**MAMARONECK BEACH AND YACHT  
CLUB 555 SOUTH BARRY AVENUE  
VILLAGE OF MAMARONECK, NEW YORK**

**FINAL SUPPLEMENTAL ENVIRONMENTAL IMPACT STATEMENT  
PROPOSED SANITARY SEWER SYSTEM UPGRADE**

**VOLUME 1**  
February 14, 2018

INDEX OF COMMENTS AND RESPONSES				
Comment source/Key		Commentator	Issue	Comment/ Response Number
Document	Location			
Memo 6/13/16	Pg. 1, para. 3	BFJ Planning	Existing Sewer Line	1A
Memo 6/13/16	Pg. 1, para. 4	BFJ Planning	Existing Sewer Line	1B
Memo 6/13/16	Pg. 1, para. 5 - Pg. 2, para. 1	BFJ Planning	Existing Sewer Line	1C
Letter 6/7/16	Pg. 1 para. 2	Debora S. Cohen, Newman Ferrara LLP	Existing Sewer Line	1D
Letter 5/11/16	Pg. 2, para 3 - Pg. 4 para. 2	Daniel Natchez, President Daniel S. Natchez and Associates, Inc; Shore Acres Property Owners Association	Existing Sewer Line	1E
Letter 5/25/16 Tafur	Pg. 2-3, Item 3	Victor M. Tafur, Resident of 490 Bleeker Avenue	Existing Sewer Line	1F
Email 6/6/16 Hillyer	Pg. 1, para. 5 - Pg. 2, para. 1	Christopher D. Hillyer, Resident of 506 South Barry Avenue	Existing Sewer Line	1G
Email 6/6/16 Hillyer	Pg. 3, para. 1, line 1	Christopher D. Hillyer, Resident of 506 South Barry Avenue	Existing Sewer Line	1H

*PREVIOUS EXHIBIT 8 now removed from Final DSEIS for public review*

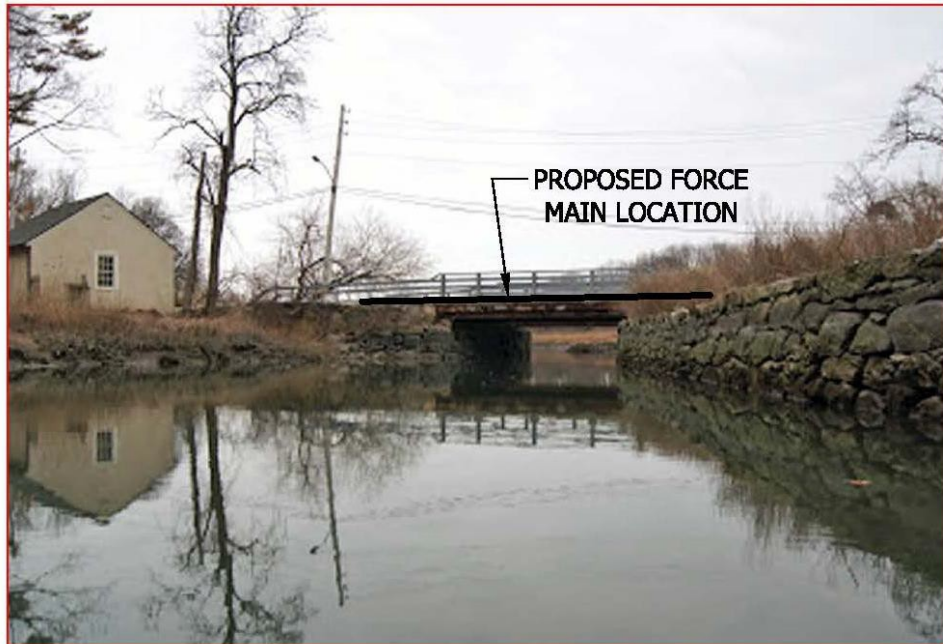
**COMMENT 8.C:**

It is unclear why the above referenced “Exhibit 8,” which was included in previous iterations of the DSEIS, has been removed from the final DSEIS submitted and accepted by the Board last month. That illustration aided greatly in the understanding of the alternative and clearly showed an option of running the pipe alongside the bridge deck at a level similar to the water line that runs adjacent to the east side of the bridge. A copy of the image from that exhibit is included here:

Your attention is directed to the *previous DSEIS Exhibit 8* (shown above) and current DSEIS Exhibits 8b and 8a, which clearly show, probably better than we can describe, why being over the west side of the bridge from a visual, environmental and practical approach makes more sense. *Daniel Natchez, President Daniel S. Natchez and Associates, Inc; Shore Acres Property Owners Association, Letter, May 11, 2016, Pg. 9, para. 1 - 8*

SCHEMATIC PIPELINE BRIDGE (PLAN)

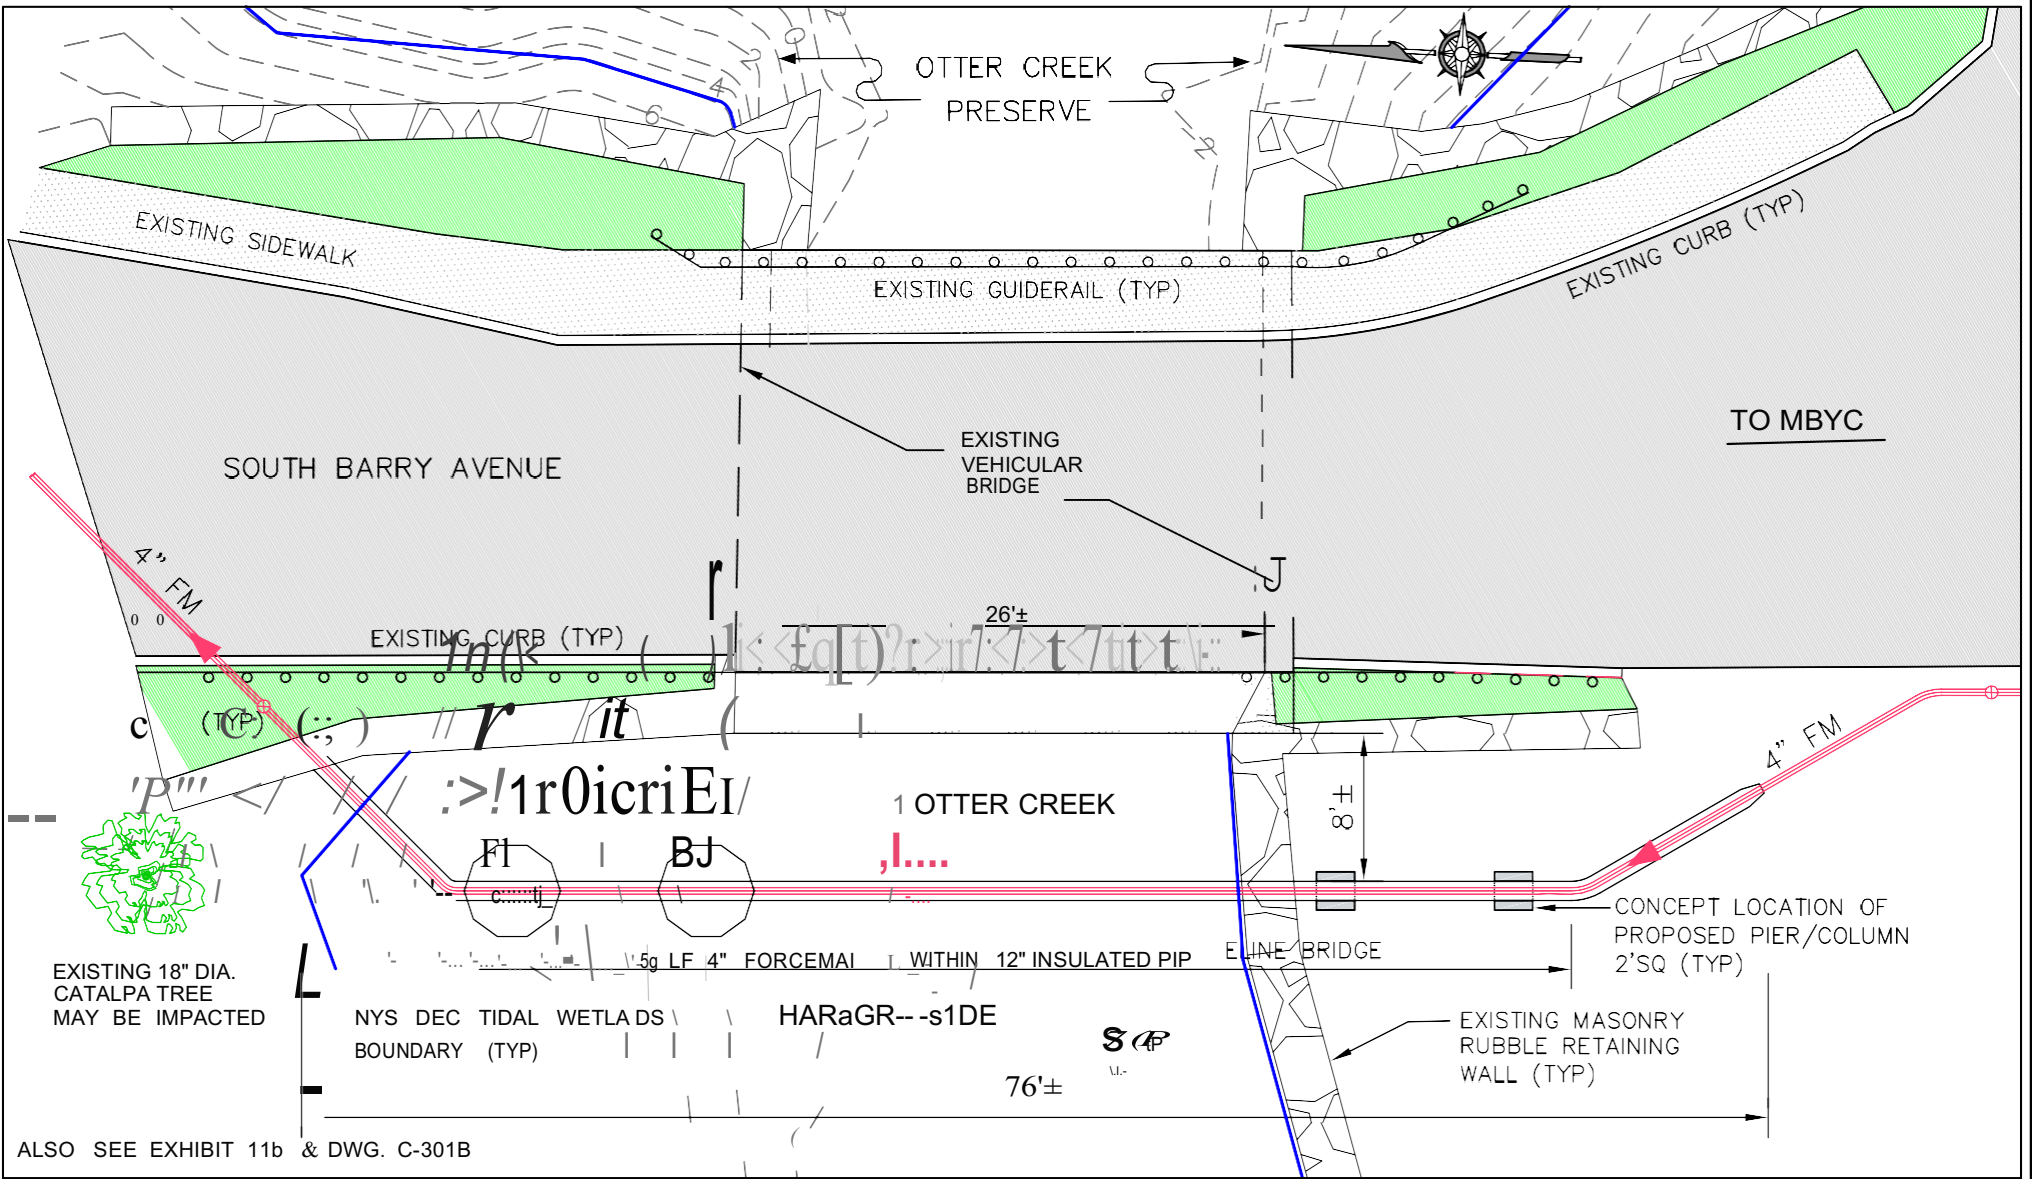
close to a detached garage, as well as what appears to be a storm drain. The detached garage is depicted on Exhibit 7 but not on Exhibit 8a. The storm drain appears on Google Street View (August 2013). Potential impacts to these structures should be addressed. *BFJ Planning, Memorandum, June 13, 2016, Pg. 6, para. 2*
